**Advice 6663-E**

Public Utilities Commission of the State of California

**Subject: Advice Letter Modifying Electric Rule 21 Pursuant to Resolution E-5172**

Figure Hh-2: Active Power as a Function of System Frequency

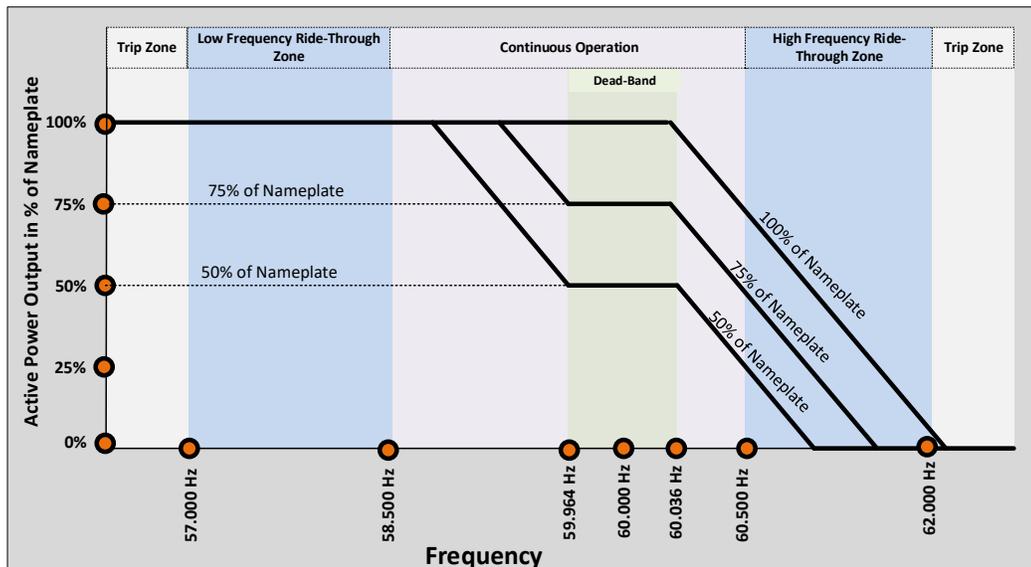
- When system frequency moves under 59.964 Hz, the active power output produced by the Smart Inverter shall be increased by 50% of real power nameplate rating per hertz (5% of real power nameplate rating increase per 0.1 hertz) when inverter is capable of increasing active power output.
- The default dead-band should be +/- 0.036 Hz from 60 Hertz (59.964 Hz to 60.036 Hz). When the system frequency is in range of 59.964 Hz and 60.036 Hz, the Smart Inverter is not required to decrease power as a function of system frequency.
- Open loop response time for Frequency –Watt shall be 5 seconds.
- Figure Hh-2 illustrated this requirement for three levels of output power. Figure Hh-2 is for illustration purposes only.

Figure Hh-2: Active Power as a Function of System Frequency

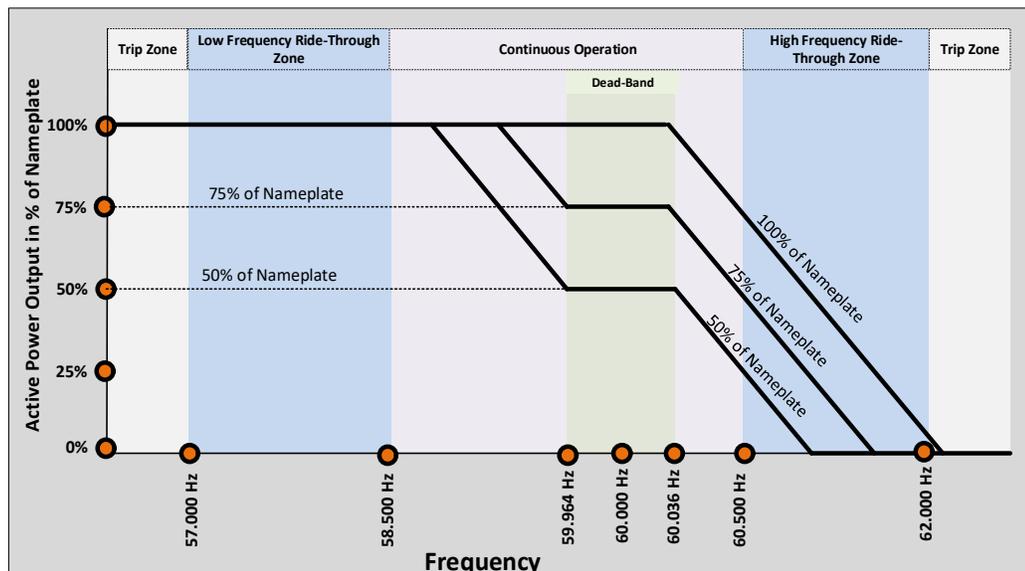
- When system frequency moves under 59.964 Hz, the active power output produced by the Smart Inverter shall be increased by 50% of real power nameplate rating per hertz (5% of real power nameplate rating increase per 0.1 hertz) when inverter is capable of increasing ~~real power production~~ active power output. (T)
- The default dead-band should be +/- 0.036 Hz from 60 Hertz (59.964 Hz to 60.036 Hz). When the system frequency is in range of 59.964 Hz and 60.036 Hz, the Smart Inverter is not required to decrease power as a function of system frequency.
- Open loop response time for Frequency –Watt shall be 5 seconds.
- Figure Hh-2 illustrated this requirement for three levels of output power. Figure Hh-2 is for illustration purposes only.
